## CUSTOMER TECHNICAL MEMO # 297

**Subject** Centor SURELOCK 5 Upgrade

### **New SURELOCK 5 adjustment system**

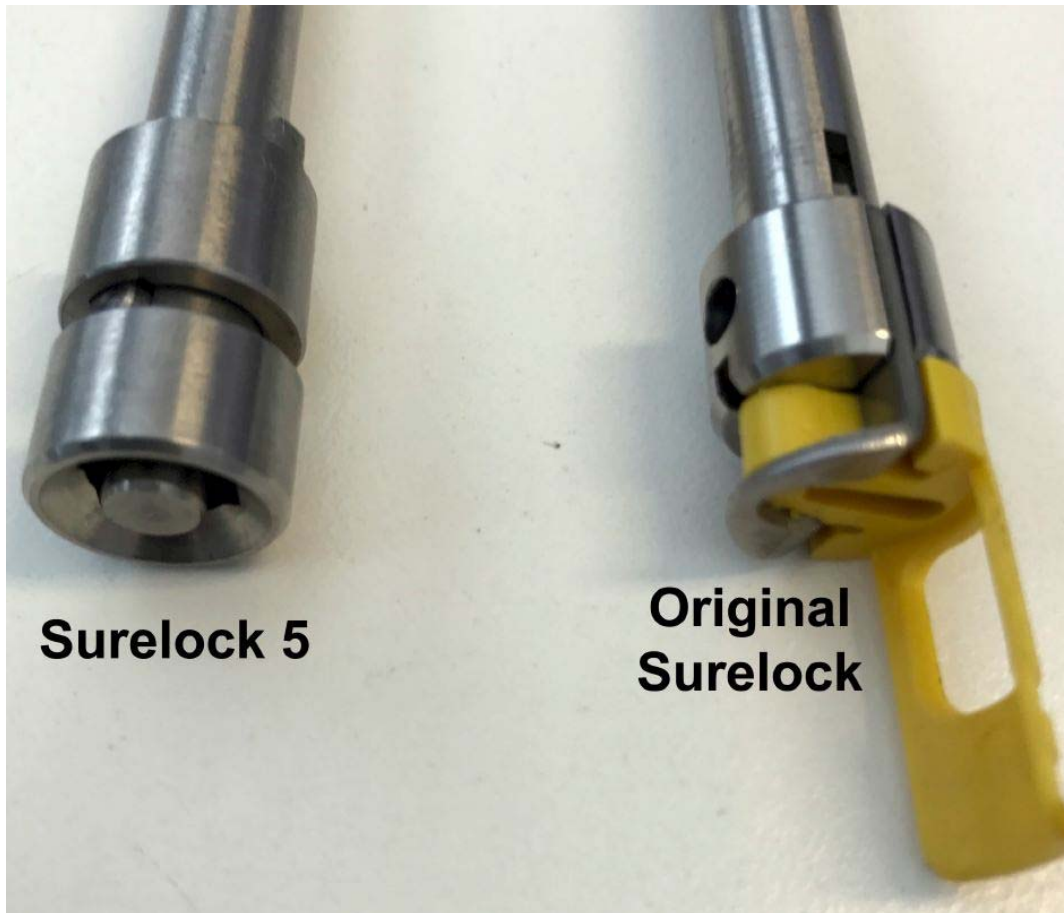
Centor have released the new SURELOCK 5 adjustment system, which is an upgrade to the E2 + E3 stainless steel bifold hardware. The major improvements are increased weight capacity, improved adjustment, and cleaner looks.

The new SURELOCK 5 adjustment system is simply operated by an Allen key as per the picture below.

- 8mm Allen key used for adjustment
- The extra torque from the allen key allows doors to be adjusted without being "un weighted"
- The yellow shipping clip is no longer required
- One handed adjustment
- Cleaner look
